**CITY OF MERIDIAN
FINDINGS OF FACT, CONCLUSIONS OF LAW
AND DECISION & ORDER**

In the Matter of the Request for Development Agreement Modification (Instrument #114030972) and to allow Preliminary Plat consisting of 94 single family lots, 92 townhouse lots and 26 common lots on 24.54 acres in the R-15 zone, by Engineering Solutions LLP.

Case No(s). H-2020-0093

HEARING DATE: 12/22/2020
 TO: Mayor & City Council
 FROM: Alan Tiefenbach
 208-489-0573
 SUBJECT: H-2020-0093
 Oakwind Estates Subdivision – PP and MDA
 LOCATION: Northeast Corner of N. McDermott Road and W. McMillan Road

A. Preliminary Plat (date: 9/1/2020 12/8/2020)

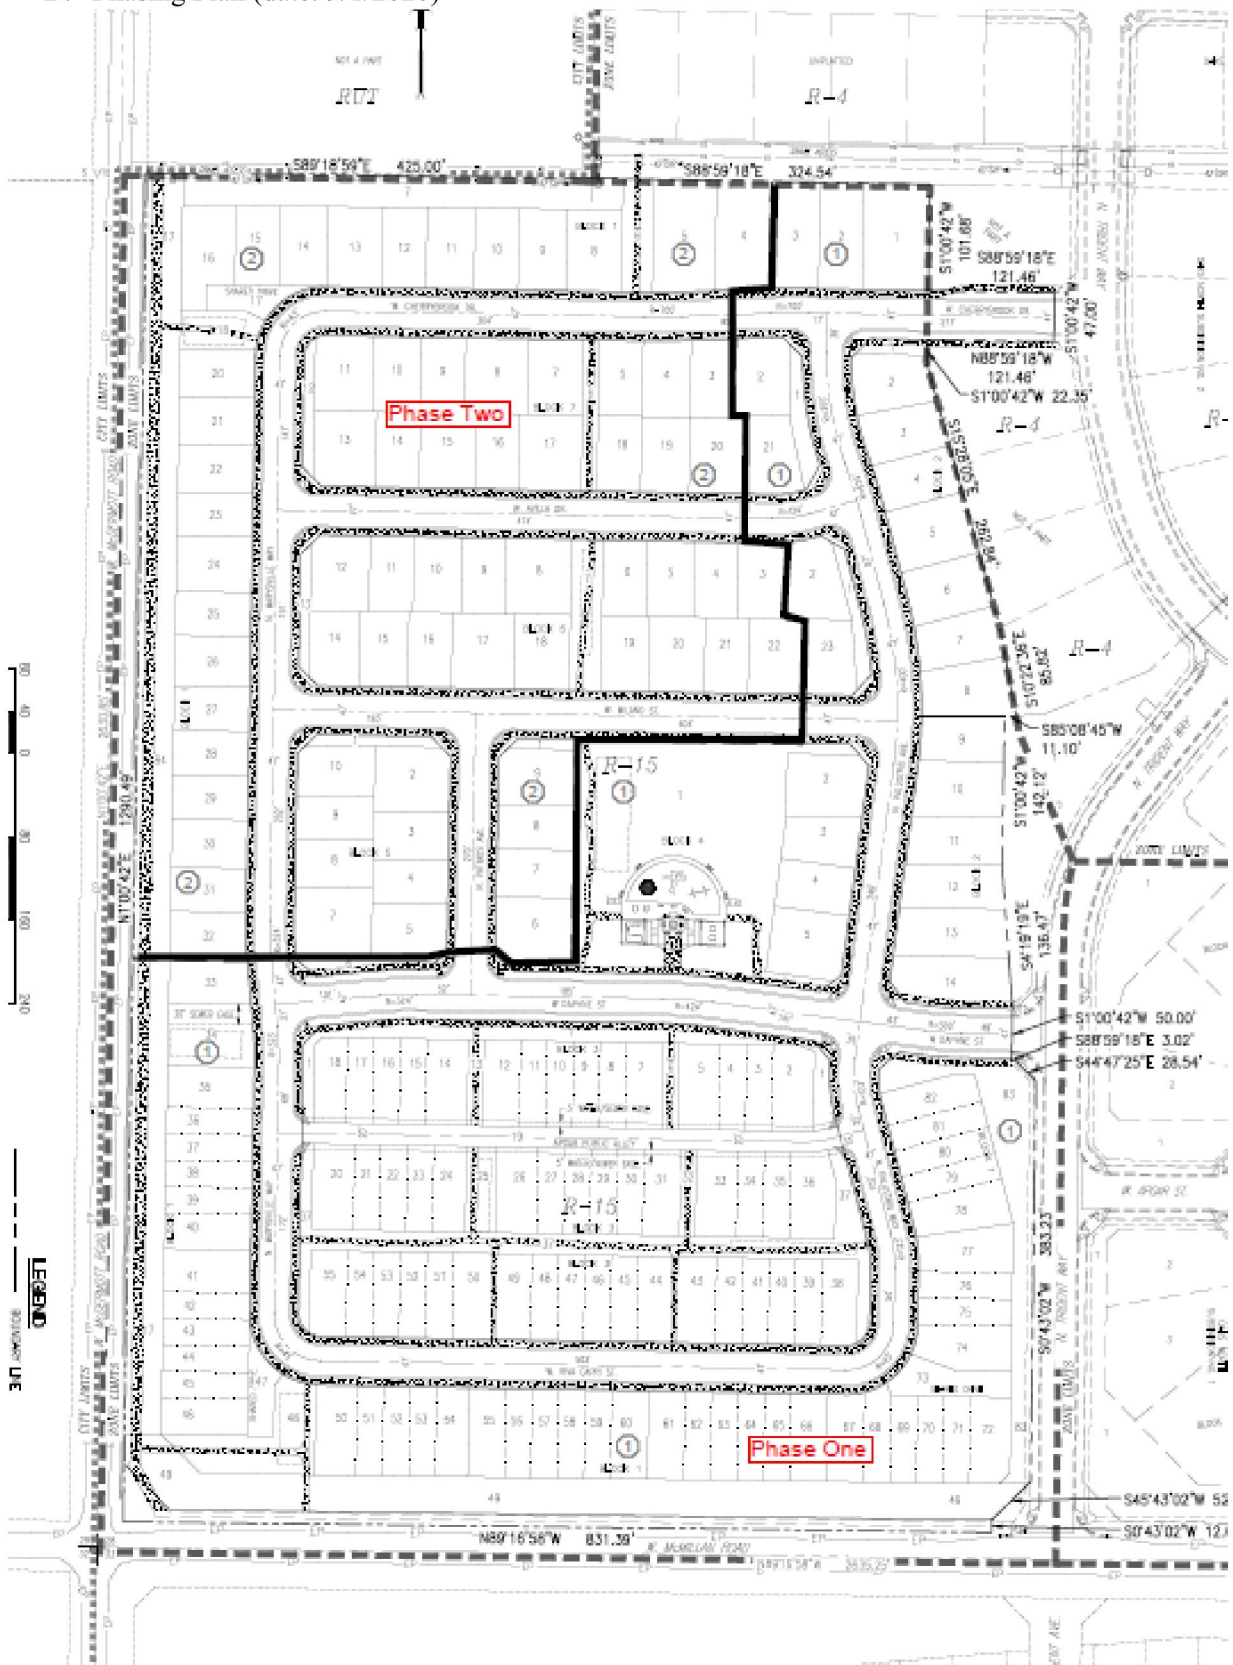
Per ACHD, Marysville Street and Palustris Avenue are proposed to be greater than 750-feet in length and will need to be redesigned to reduce the length of the roadways or to include the use of passive design elements. Stop signs, speed humps/bumps and valley gutter are not accepted as

traffic calming. Prior to City Council, the applicant should be required to submit a revised preliminary plat showing the redesigned roadways and approved by ACHD.

- a. Note #10: Revise to include Lot 84, Block 1 as a common lot to be owned and maintained by the Home Owners Association.
 - b. Marysville Street and Palustris Avenue will need to be redesigned to reduce the length of the roadways or to include the use of passive design elements. Stop signs, speed humps/bumps and valley gutter are not accepted as traffic calming. The applicant shall submit a revised preliminary plat showing the redesigned roadways and approved by ACHD prior to City Council.

F. Townhouse Parking Plan

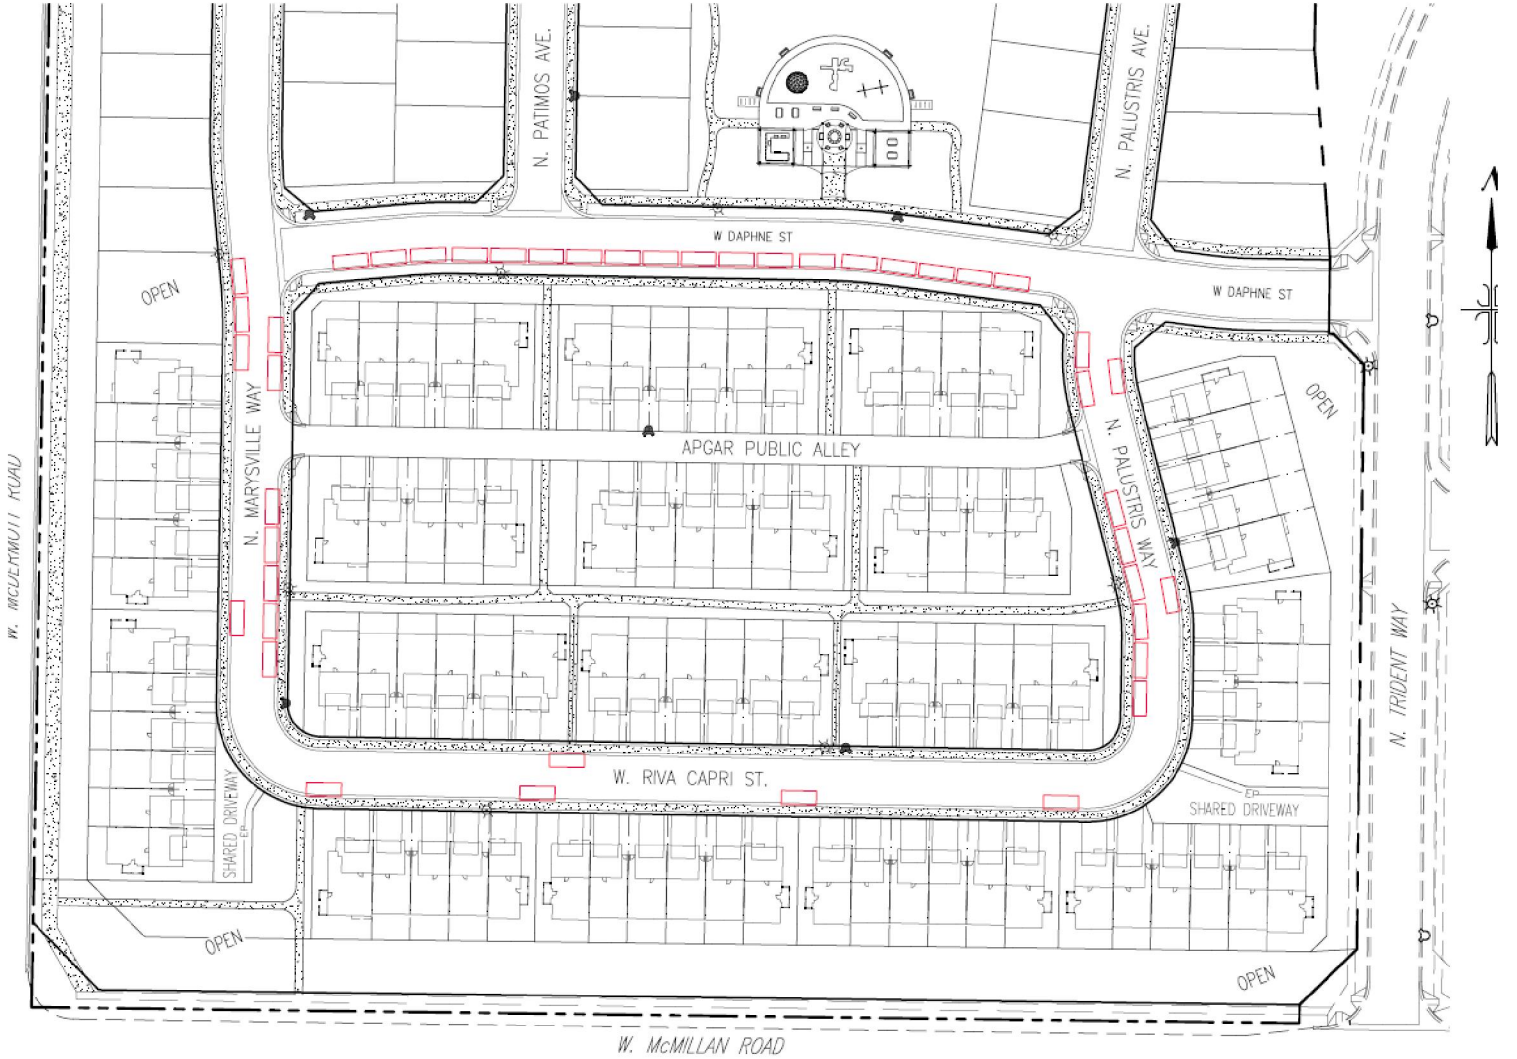
The applicant has provided a parking exhibit for the single family attached portion of the project (southern portion). The parking plan provides a 33' local street section which allows for additional on-street parking. It is important to note this on-street parking does not count toward meeting minimum requirements. ACHD and Meridian Fire have both reviewed the plan and have not expressed concerns.

- c. Expressed concerns regarding additional parking in the townhouse portion.
 - d. Preferred additional open space for the townhouse portion.
- 4. Commission change(s) to Staff recommendations (A new plat, amenity exhibit, landscape plan and elevations have been updated with the staff report to reflect the changes required by the Commission and ACHD. The applicant has not provided additional open space or parking):
